UNITED STATES PATENT AND TRADEMARK OFFICE

| APPLICATION NO. | FILING DATE | FIRST NAMED INVENTOR | ATTORNEY DOCKET NO. | CONFIRMATION NO. |
|--|-------------|----------------------|---------------------------------|------------------|
| 09/857,348 | 07/24/2001 | Fredrik Persson | 66477-012-5 | 3135 |

Office Action Summary

DETAILED ACTION

FIG. (a)

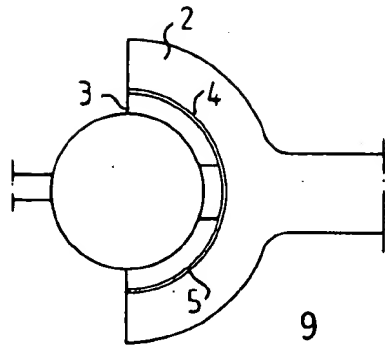
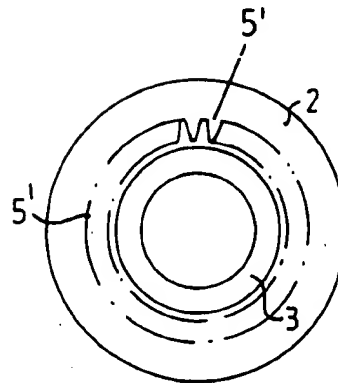
- Figure 4 as described in the specification is missing from the drawings. The two separate images associated with the labels "FIG.(a)" and "FIG.(b)" should each be separately labeled as --FIG.4a-- and --FIG.4b--, respectively.
- The numeral "9" as shown in newly amended FIG.(a) appears to be a typographical error and should be deleted.
- Figure 5 should be labeled as "prior art" since only that which is old and known is shown.

FIG. 5

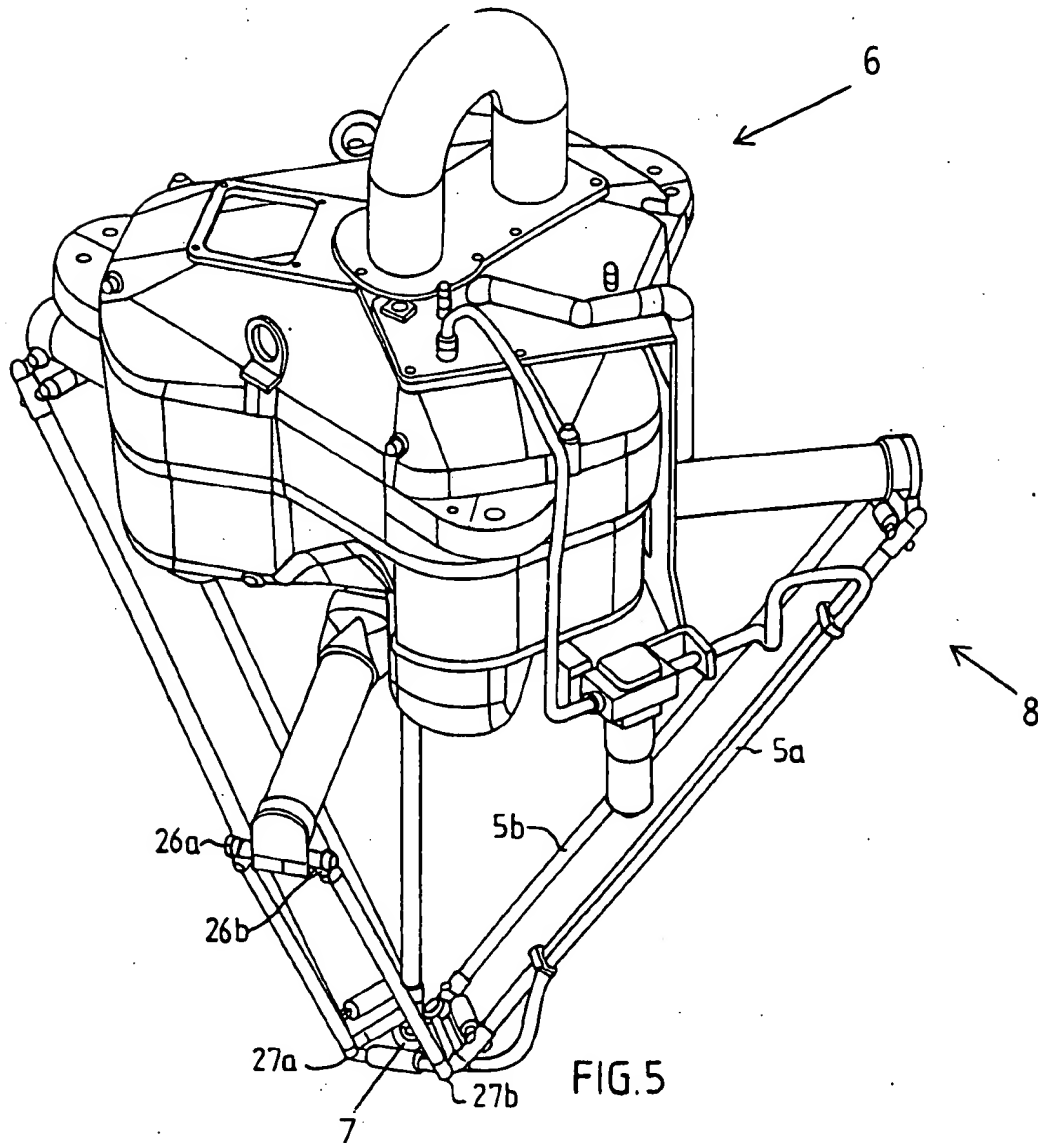
The applicant argues that figure 5 need not be labeled as prior art since it includes subject matter that was not known prior to applicant's invention. This is not persuasive. First, applicant has failed to identify any specific elements in figure 5 that are not prior art. Second, applicant's specification as originally filed (p.1, ll.10-15) stated that figure 5 was prior art. Once an

applicant admits that a figure is prior art such admission cannot be retracted. Also note that applicant's figure 5 as filed on July 11, 2006 clearly labeled figure 5 as prior art.
